STAFF RECOMMENDATION 3901 Kimpalong Avenue October 21, 2015

Application: Demolition; New construction – infill and outbuilding
District: Woodlawn West Neighborhood Conservation Zoning Overlay
Council District: 24
Map and Parcel Number: 10316009300
Applicant: Brady Fry
Project Lead: Sean Alexander, sean.alexander@nashville.gov

<p>Description of Project: The applicant proposes to demolish a non-contributing house and to build a new house and outbuilding. The outbuilding will not be used as an accessory dwelling.</p> <p>Recommendation Summary: Staff recommends approval of the proposed demolition, infill and outbuilding with the conditions that:</p> <ul style="list-style-type: none">• The brick, roof color and window and door selections are approved by MHZC Staff prior to purchase and installation;• The upper level material be stucco or the walls be flush;• The front parking space is eliminated;• The HVAC be located behind the midpoint of the building or on the rear; and,• The street-facing garage bays have individual doors. <p>Meeting those conditions, Staff finds that the project will meet the design guidelines for new construction in the Woodlawn West Neighborhood Conservation Zon

3901 Kimpalong Avenue

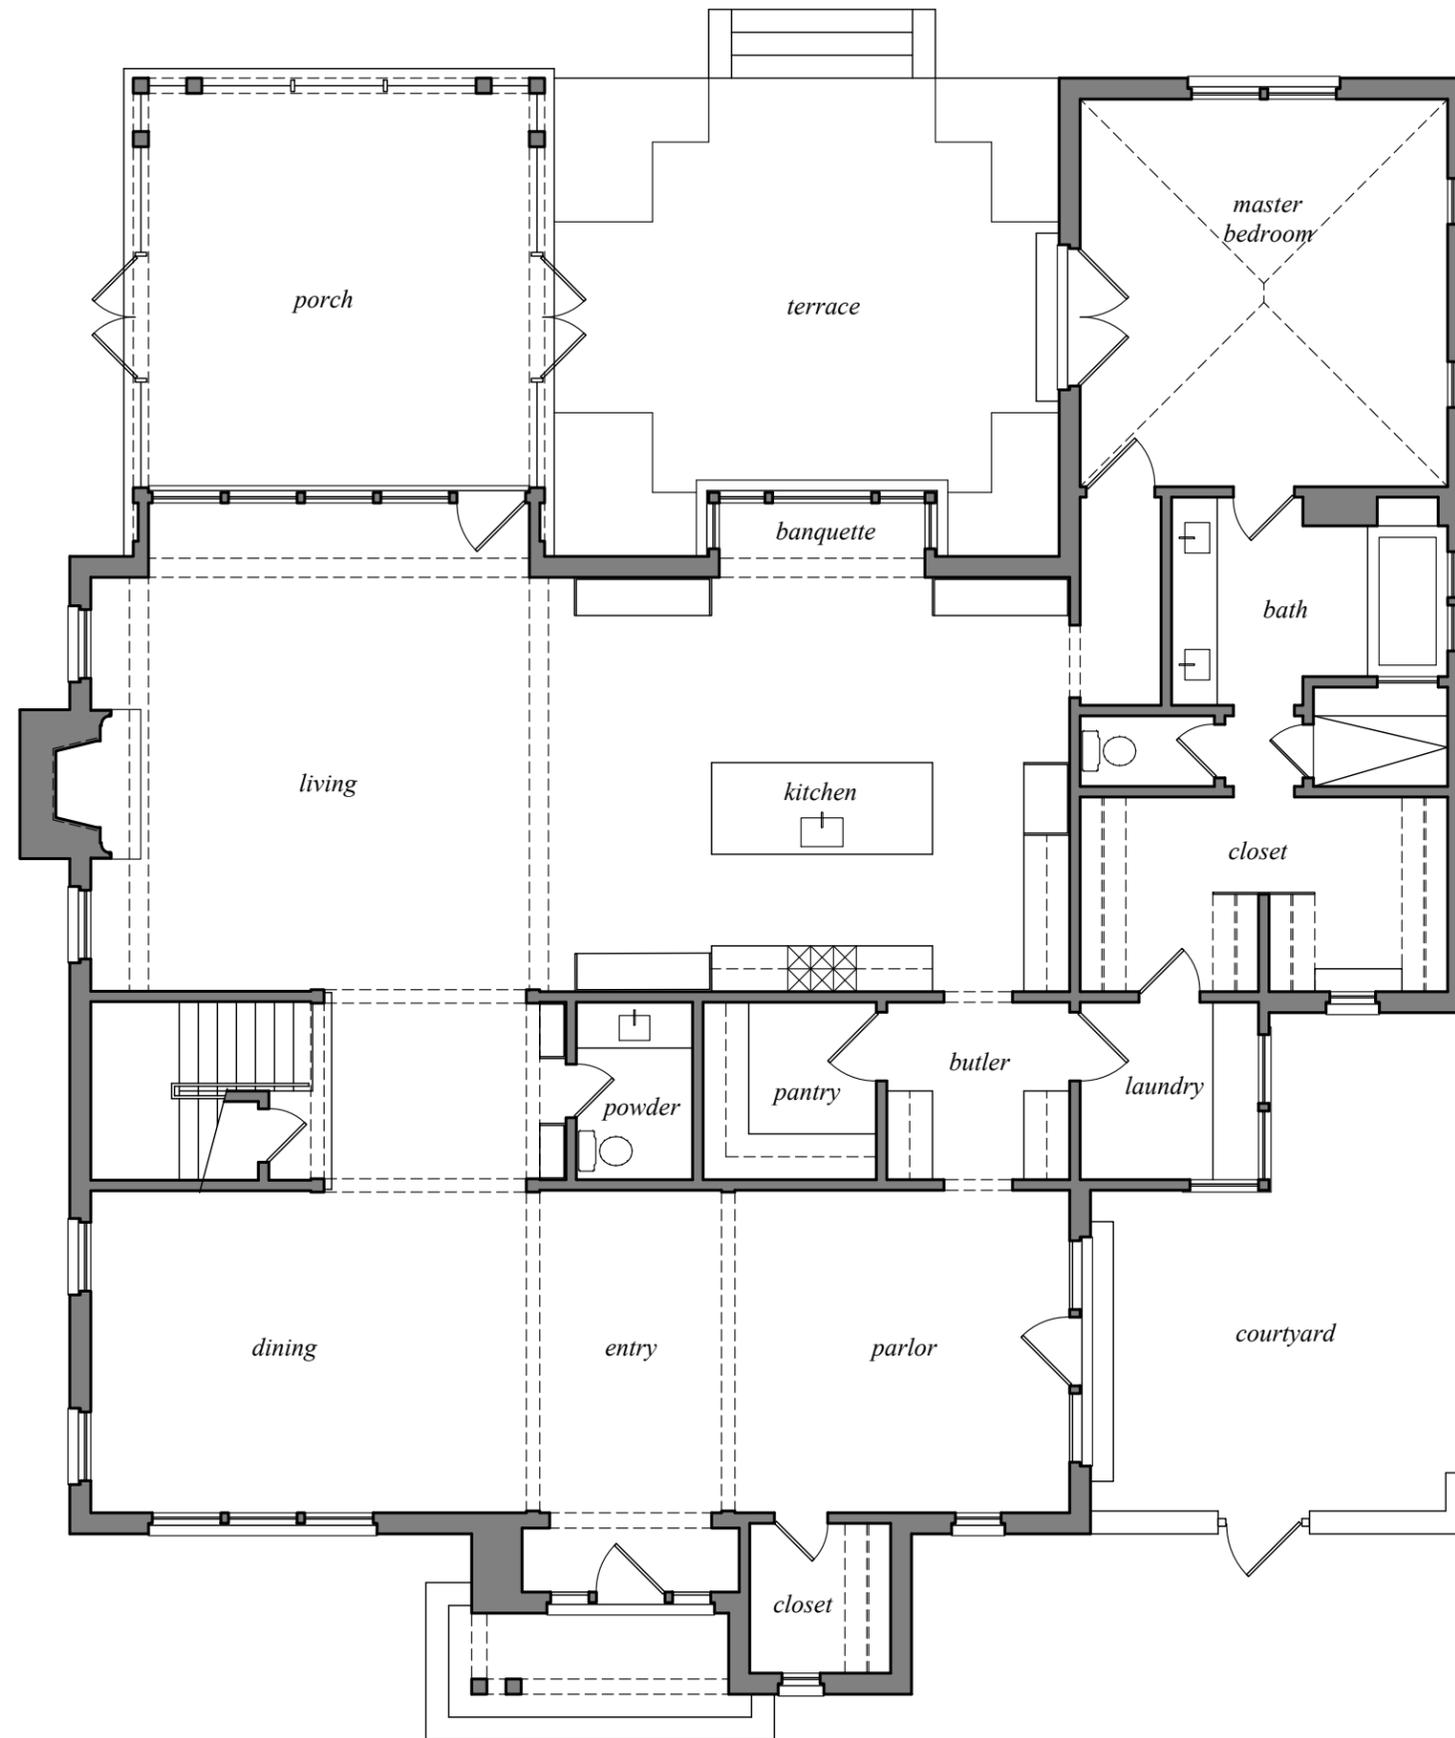
The house will match the orientation of historic houses on the street, with a front facing vestibule entrance, with a walkway leading to a driveway along the left side of the house. The site plan shows a guest parking spot off of the driveway in front of the house. Front parking is not typical of the historic context, so staff that this parking be eliminated. With a condition that the front parking spot is eliminated, Staff finds that the proposal will meet section II.B.1.f of the design guidelines.

Other than the walkway and driveway, there were no appurtenances indicated on the site plan, and the location of the HVAC and other utilities was also not noted. Staff asks that the HVAC be located on the rear façade, or on a side façade beyond the midpoint of the house. The project meets section II.B.1.h.

- The brick, roof color and window and door selections are approved by MHZC Staff prior to purchase and installation;
- The upper level material be stucco or the walls be flush;
- The front parking space is eliminated;
- The HVAC be located behind the midpoint of the building or on the rear; and,
- The street-facing garage bays have individual doors.

front elevation

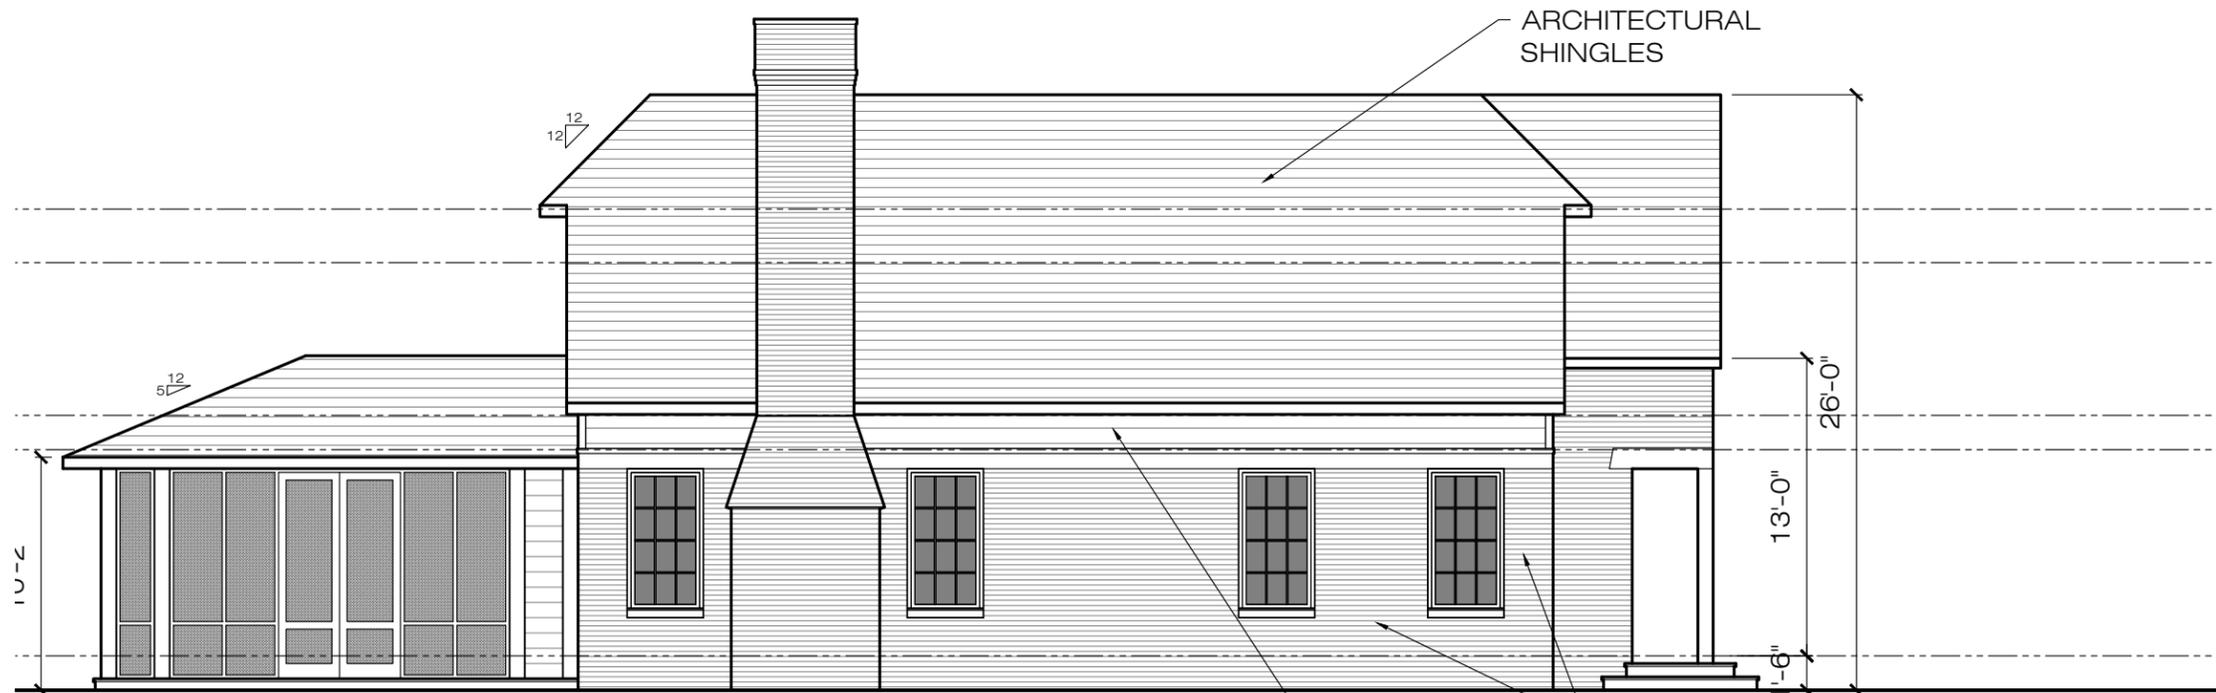
The new house will be clad with brick on the first story and the wall of a front projecting gable, and the upperstory will be clad with smooth face cement fiberboard with a reveal of five inches (5"). The upperstory wall will sit back approximately four inches (4') back from the first story wall below, a common configuration on historic Tudor Revival style houses, but typically the upperstory walls are stucco. Staff asks as a condition that the upperstory walls be stucco, or if the upperstory exterior material is siding that the wall be flush with the first story wall below. The trim will be wood or cement-fiber siding. The foundation will be brick, and the roof will be architectural fiberglass shingles. The color of the roof has not been determined. The material selections for the windows and doors also have not been determined, and staff asks to approve the final window and door selections prior to purchase and installation. With the staff's final approval of the roof color and the windows and doors, staff finds that the known materials meet section II.B.1.d of the design guidelines.

The primary roof of the new building will be a cross-gable with clipped ends, with a front projecting gable over the front entrance. The pitch of the cross-gable will be 12:12, and the front-gable roof will have a 16:12 pitch. The one-story projection on the right side will have a hipped roof with a 5:12 pitch, which. Steep roofs with multiple pitches are common to Tudor Revival style houses, which are prevalent in the surrounding context. Staff finds the project to meet section II.B.1.e of the design guidelines.

garage

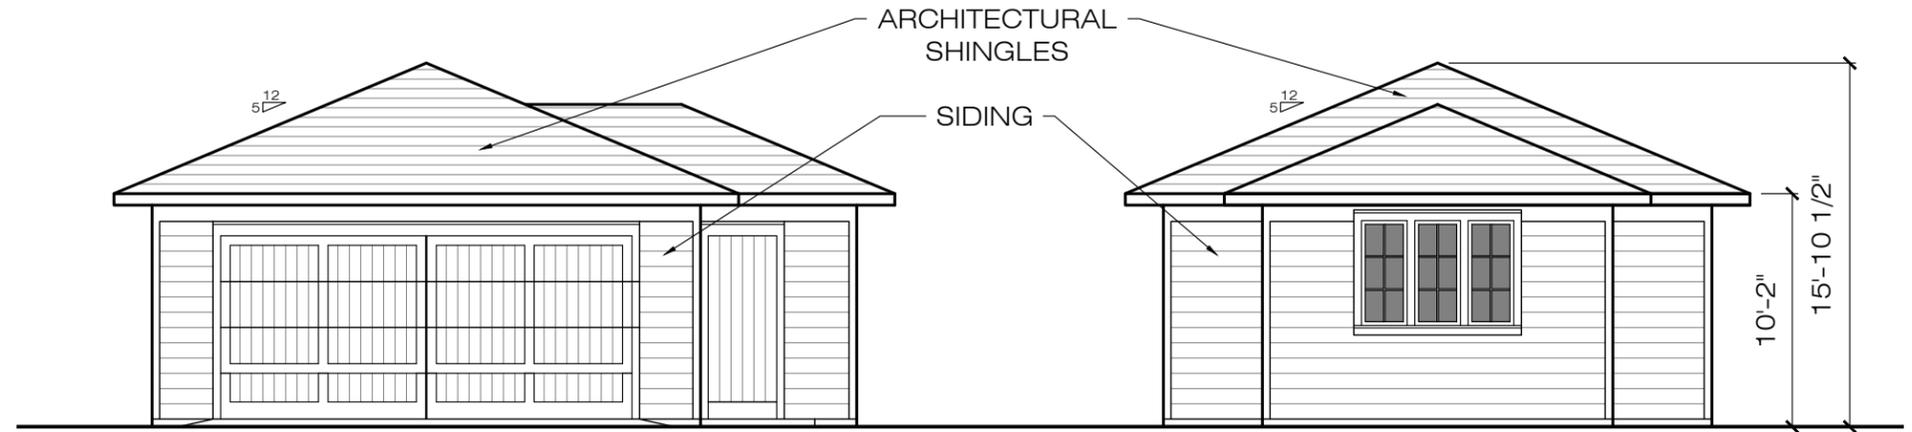
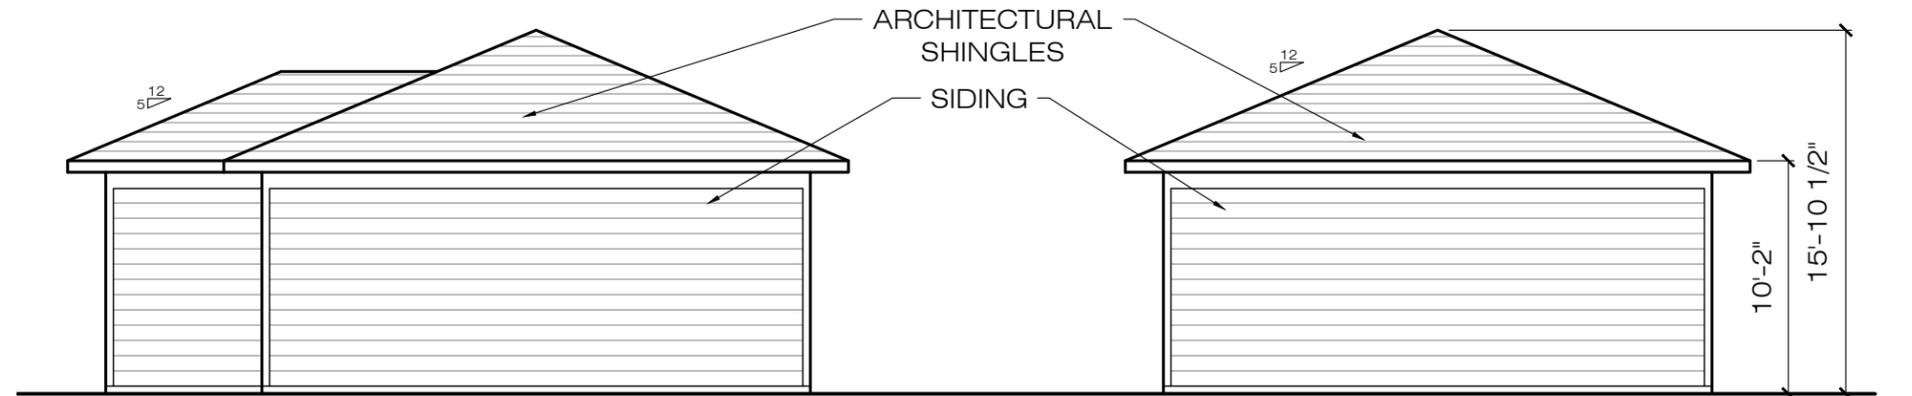
The project includes a new outbuilding at the rear of the lot. The building will be sixteen feet (16') tall with an eave height of nine feet, six inches (9'-6) and a footprint covering eight hundred square feet (800 s.f.). On lots greater than ten thousand square feet (10,000 s.f.) in area, garages can have a footprint up to one thousand square feet (1,000 s.f.). The materials will match those of the addition including cement-fiber siding and an asphalt shingle roof. As proposed, the outbuilding would have a two-bay, eighteen foot (18') wide garage door facing the street. The Commission has typically required the bays on street-facing garages to have individual doors, as is typical of historic outbuildings. The building will be located at the rear of the lot accessed from the driveway to the street. There is no alley at the rear of the lot, and the building will not be used as a detached accessory dwelling unit.

With a condition that the street-facing bays to have individual doors, Staff finds the proposed outbuilding to be subordinate to the principal building and to meet section II.B.1.i of the design guidelines.
